Second modification request to: Increase # of dwelling units from 9 to 14, eliminate office space, reduce retail space from 4,600 SF to 1,700 SF, and change west facade and outdoor patio.

Project / Development Name (if applicable): 124 East Broadway

RNA-DRB-20-05 & HPZ-20-047 (T20SA00220)
VFW Renovation - Revision Two Changes
114-124 E Broadway Boulevard

Modifications to Approved Plans

**DEVELOPMENT PACKAGE for
124 EAST BROADWAY
site plan**

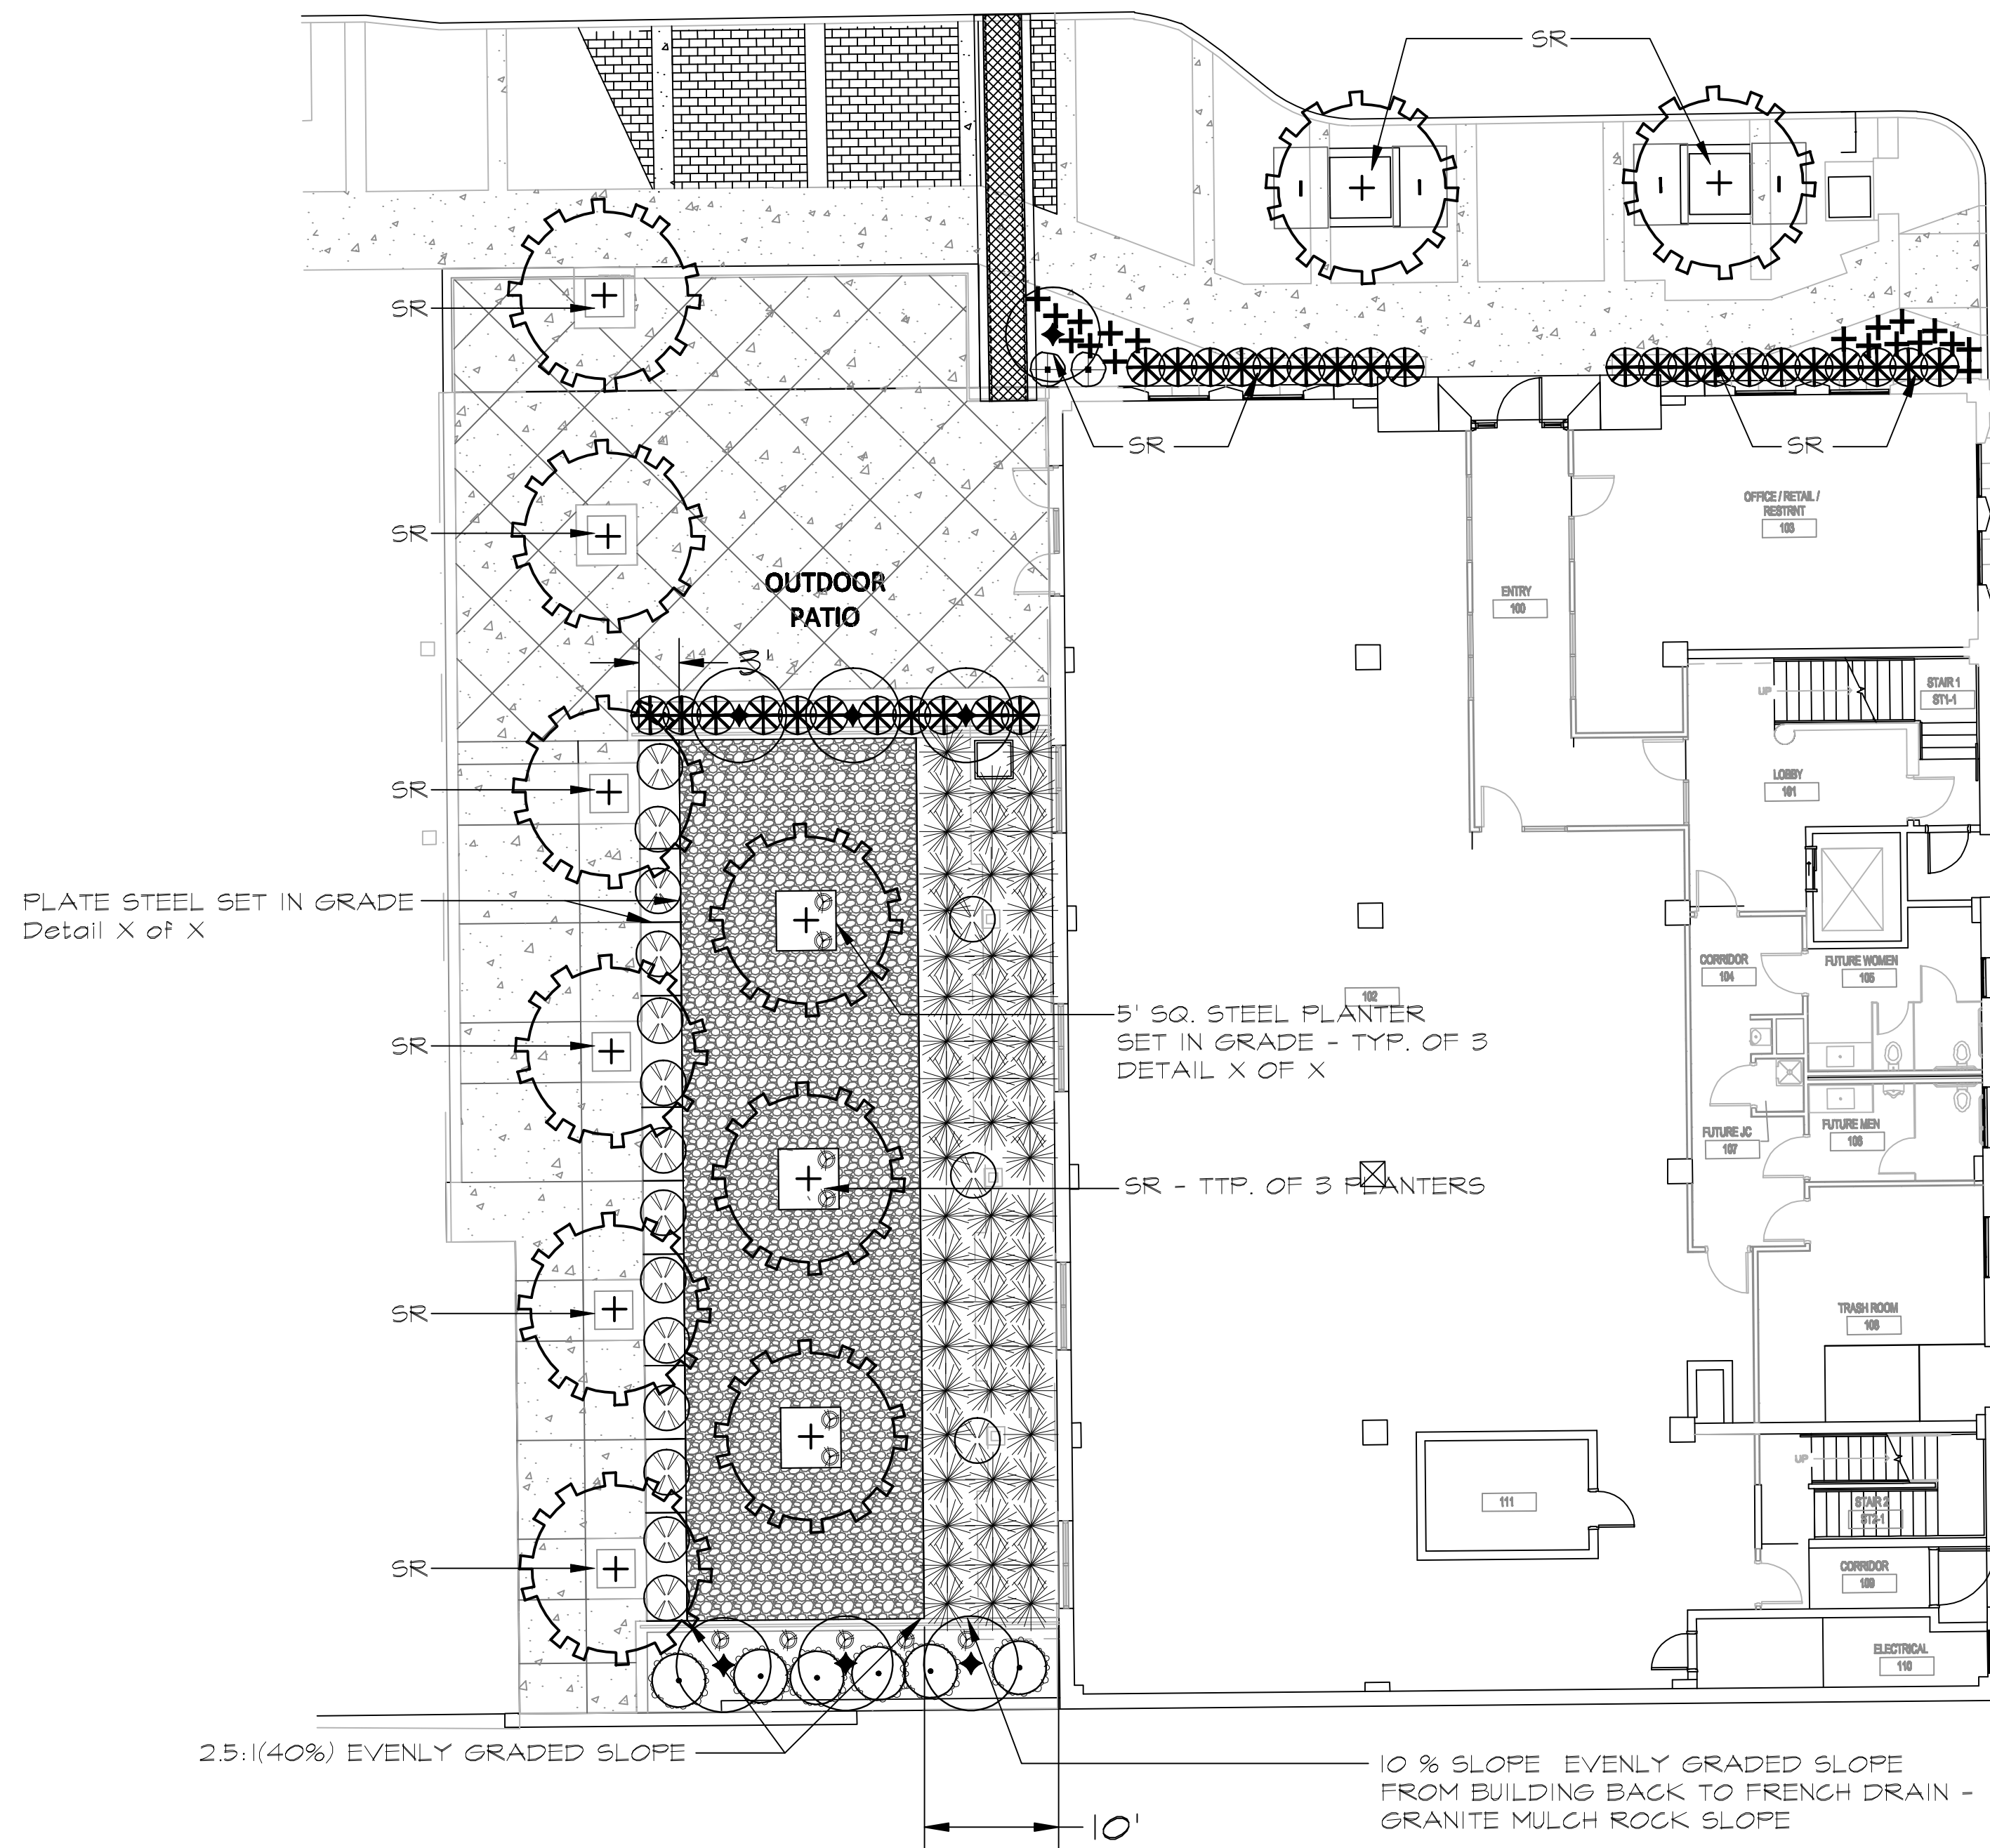
5. West Patio: patio area has been slightly increased in size. One tree is omitted due to new fence location. Elimination of this tree does not affect sun-shade study as it is not in close proximity to the public sidewalk.

West Elevation - COT 08.13.21 REV 09-09-21
SCALE: 1/8" = 1'-0"

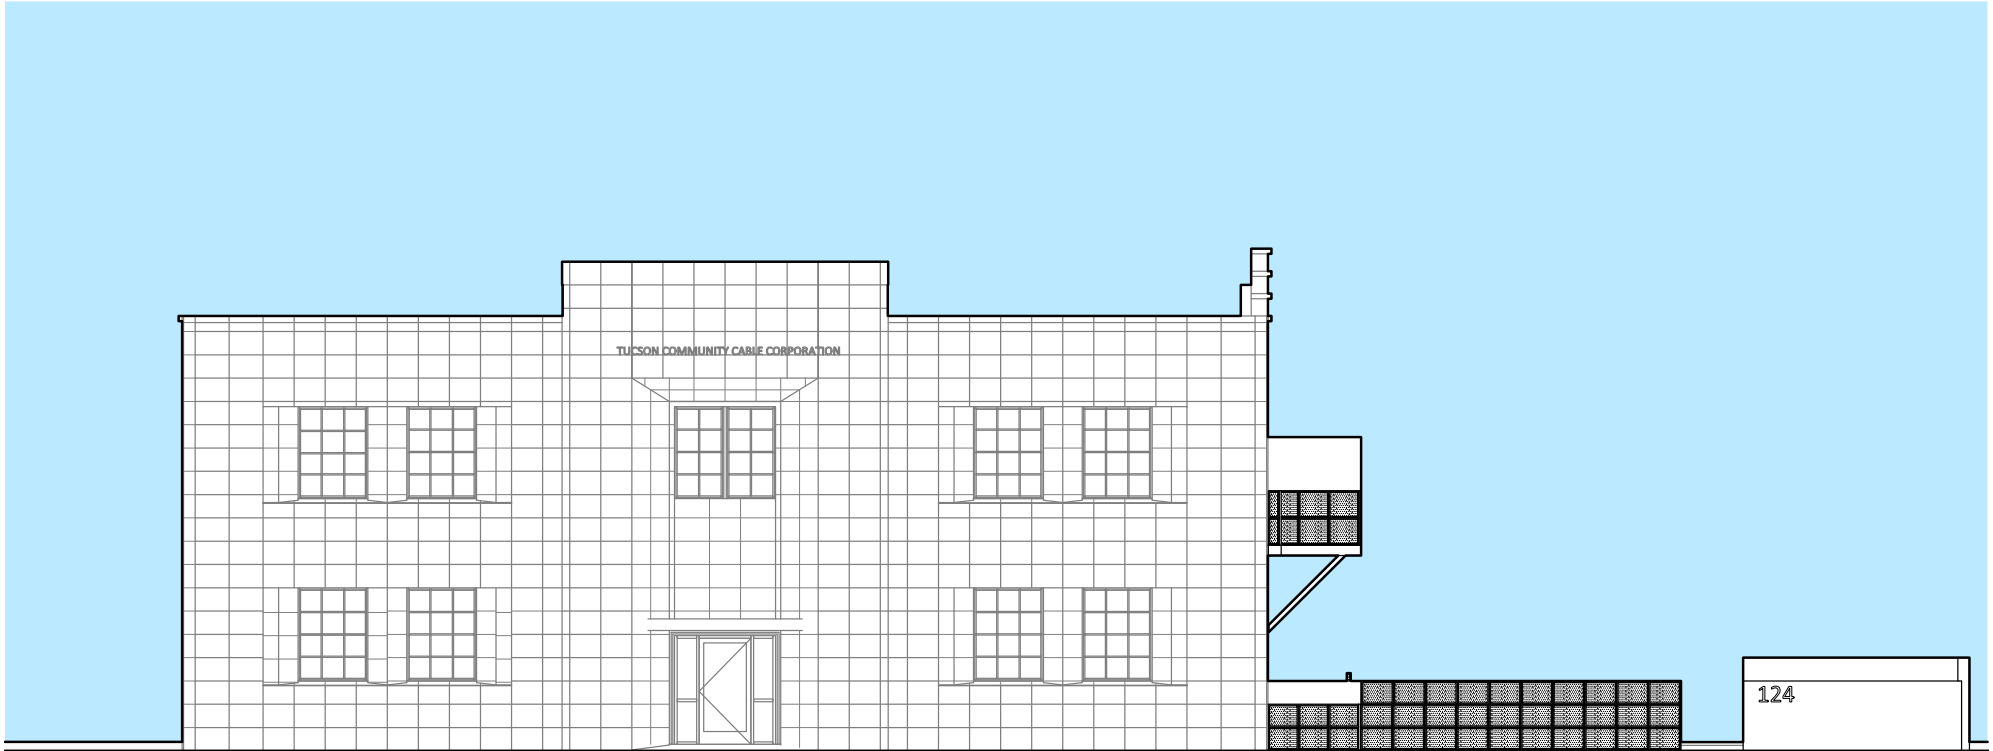
3. North Elevation: no changes.
4. West Elevation: light well has been deleted and replaced with on-grade patios for ground floor residential tenants. Privacy fencing matches material and style of previously approved fencing. **Doors to replace portion of previously approved windows.**

DOOR TO REPLACE GLAZED AREA
(TYPICAL ALL THREE UNITS)

East Elevation - COT 08.13.21
SCALE: 1/8" = 1'-0"

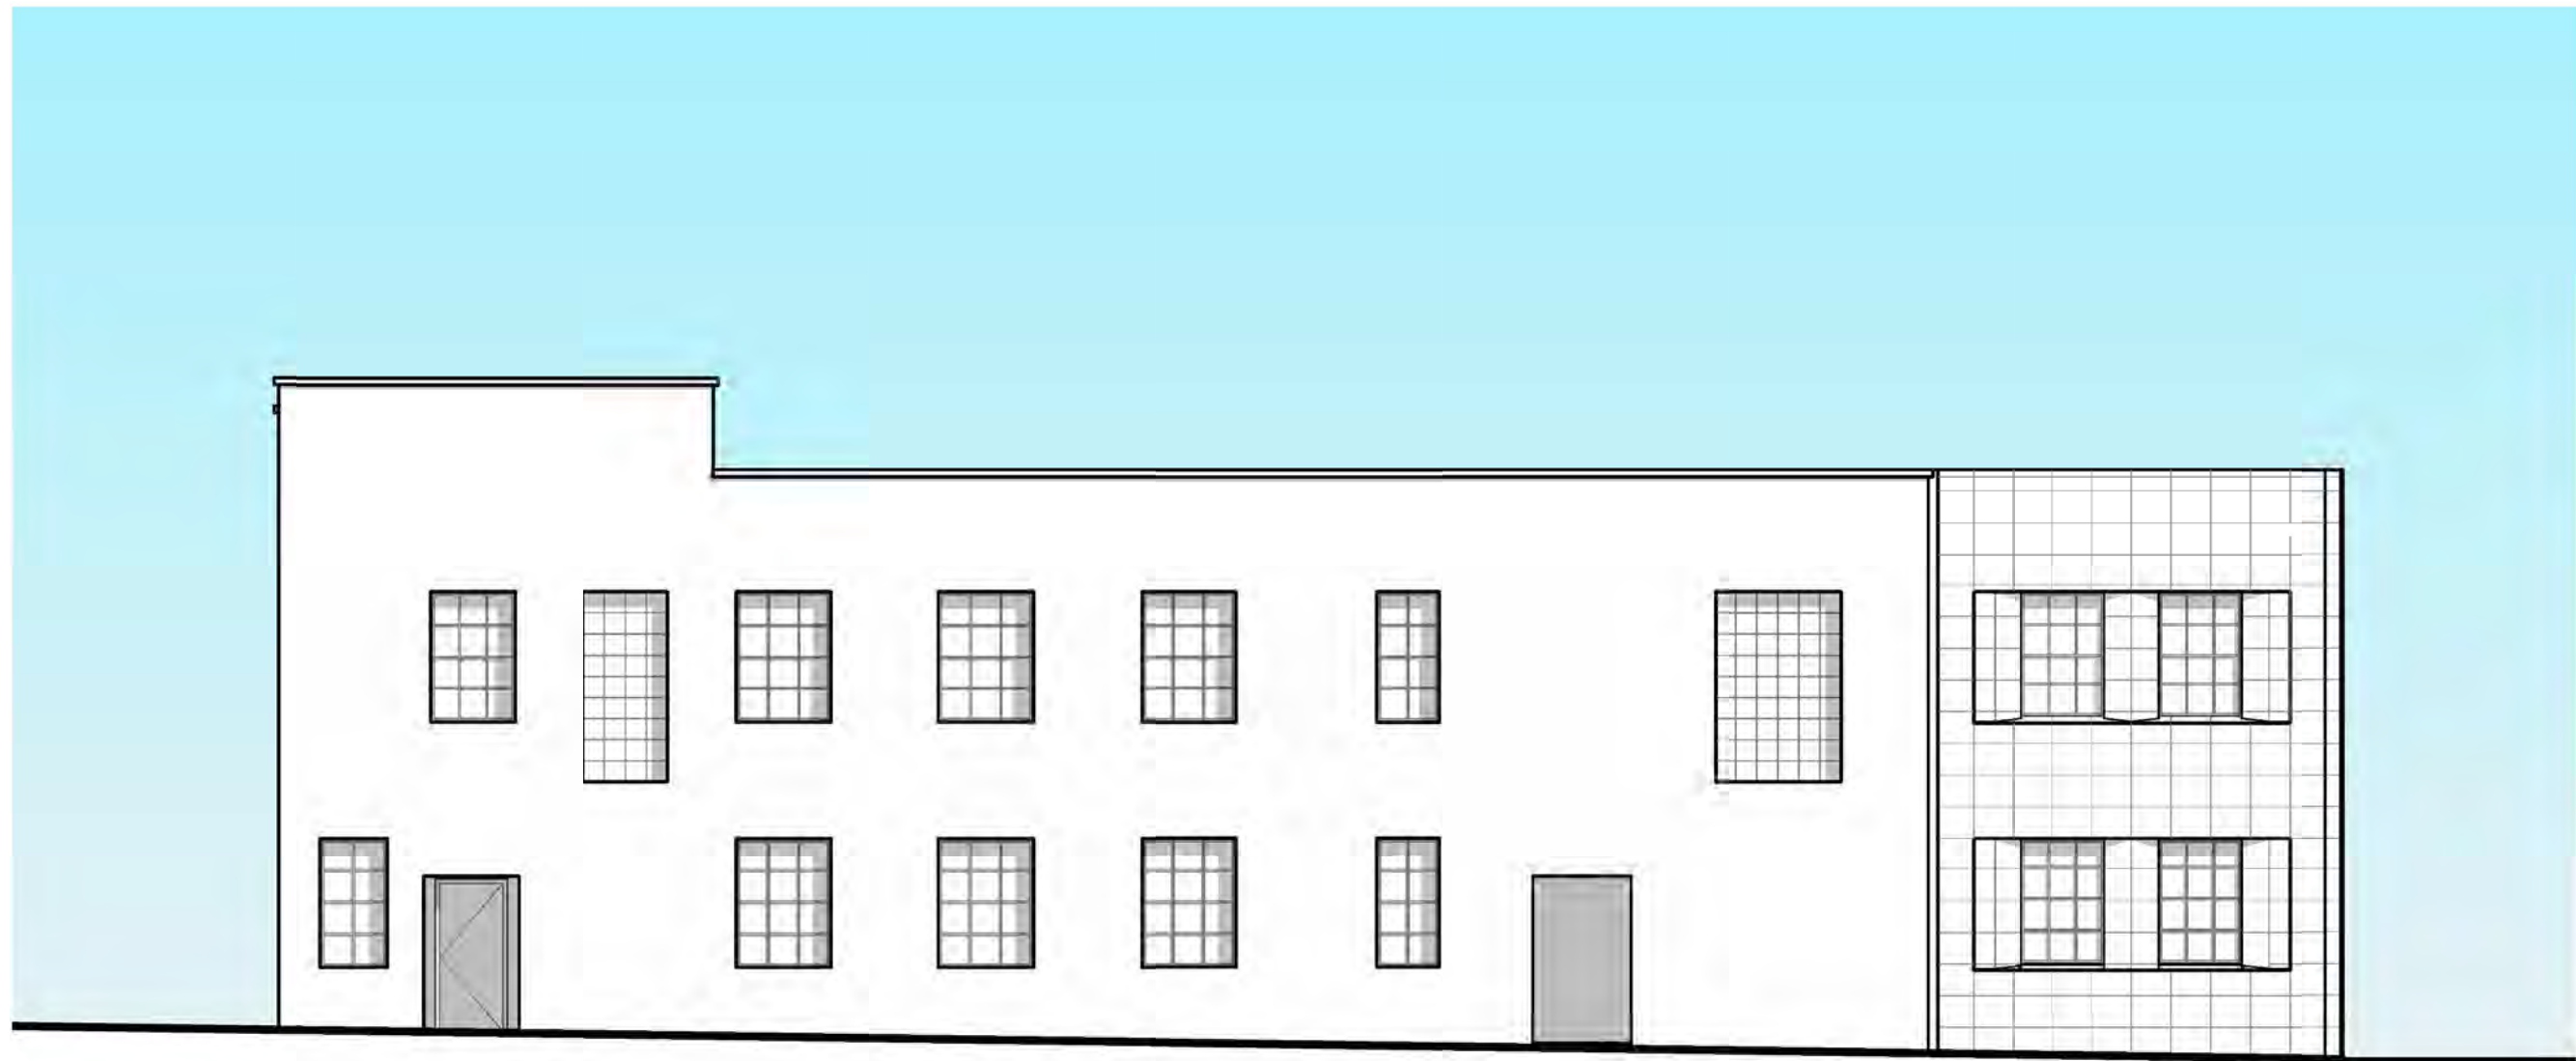
2. East Elevation: asking for approval to leave existing terra-cotta façade as-is ~~but keep in place previous approval to insert roll-up glass door, decision depending on now unknown future tenant wishes.~~
